P 29077
A 25703

SEWAGE DISPOSAL SYSTEM

MARYLAND STATE DEPARTMENT OF HEALTH*

SUBDIVISION _____ ROAD 12455 Howard Lodge Road LOT 6

INDICATE NORTH. - NAME ADJOINING ROADWAY AS BASE LINE.

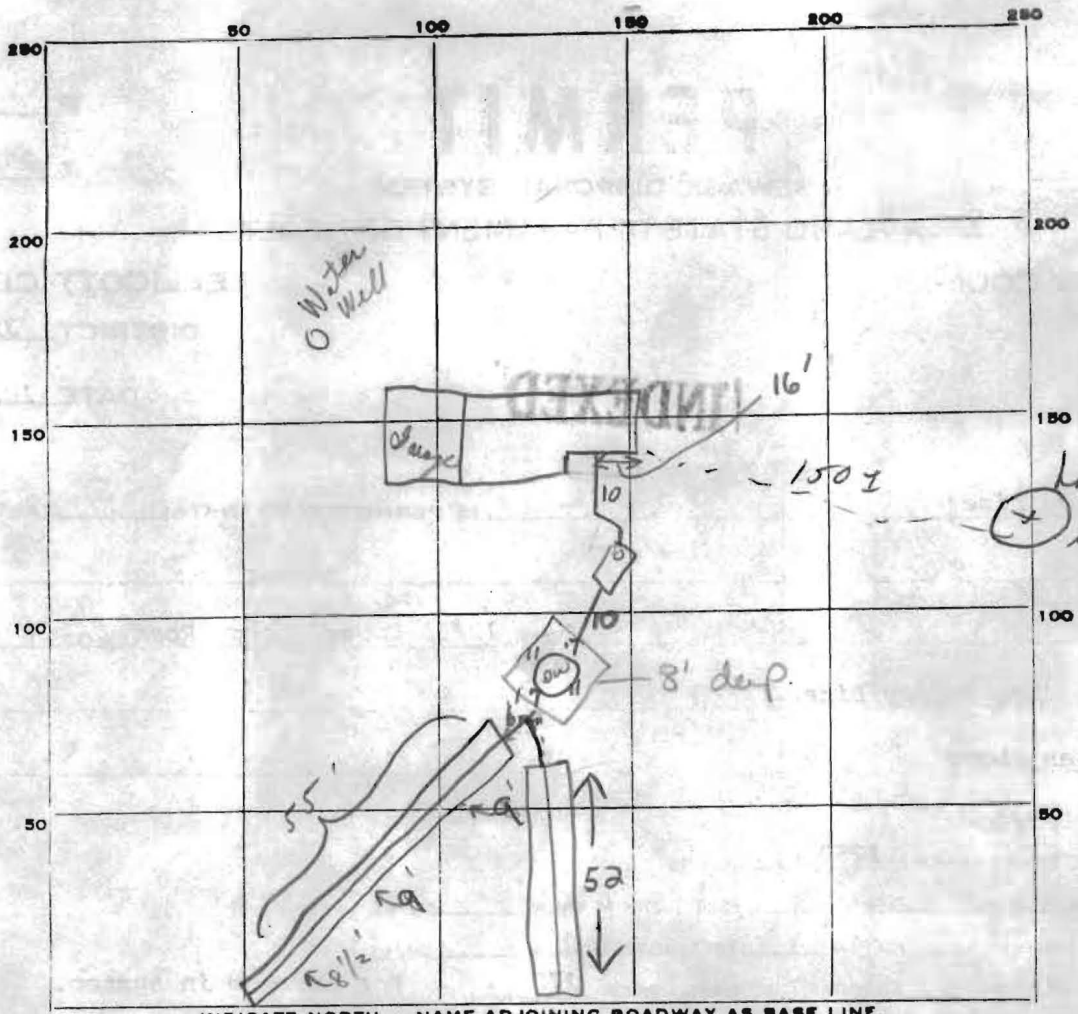
11/1/78 Howard Lodge
 (Use stop work + correct
 in window)

REMARKS 11/1/78 Stop work - spoke to Digo state
 recommend go by house plans 4/07 contact
 supervisor. Septic tank too high (out of ground)
 + dig well - range 1 completely out of ground needs to be
 deeper + trench 55' only 8' deep. Partial - nothing apparent
 6/20/78 = Call for final when gravel is added to trenches. (GLK)

DATE SYSTEM APPROVED 11/14/78
